### Service Letter

**Title:** Bell M429 Environmental Control Unit installation inspection and possible replacement

**Applicability:** Owner/Operators of Bell M429 Helicopters with STC SR00693DE Air Conditioning System

**Figure 1.2**  
**S-6063EC-1 Condenser Blower Assembly**

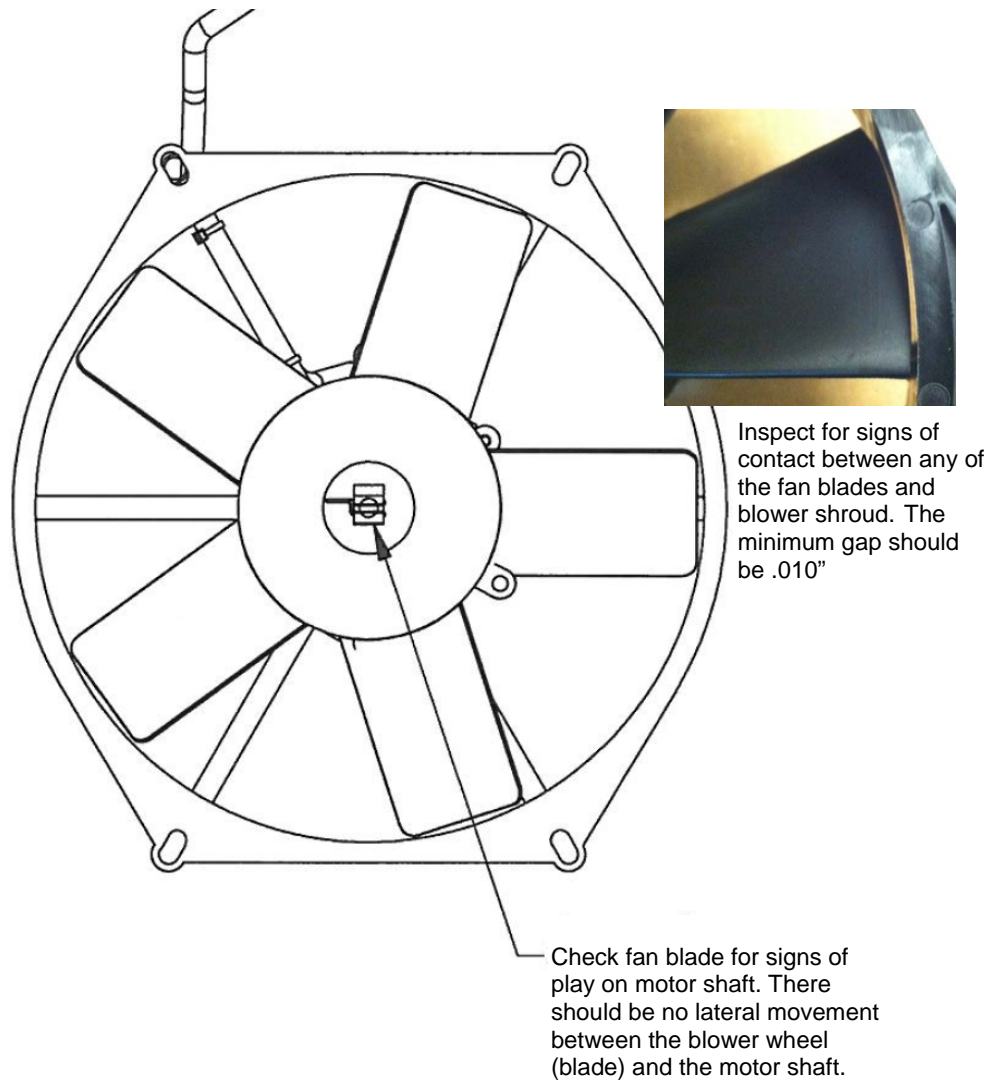
1. Prepare helicopter for maintenance.
2. Remove upper cowlings as necessary to gain access to the condenser assembly (Figure 1.1).
3. Check fan blade for signs of play on the motor shaft. (Figure 1.2) There should be no lateral movement between the blower wheel (blade) and the motor shaft. Inspect for signs of contact between any of the fan blades and blower shroud. There should be no indications of contact or rubbing between the fan blades and the shroud. The minimum gap should be .010". If any anomalies are found, contact Air Comm Corporation for guidance on disposition.
4. Secure aircraft.
5. Contact Air Comm Corporation if additional guidance is required.
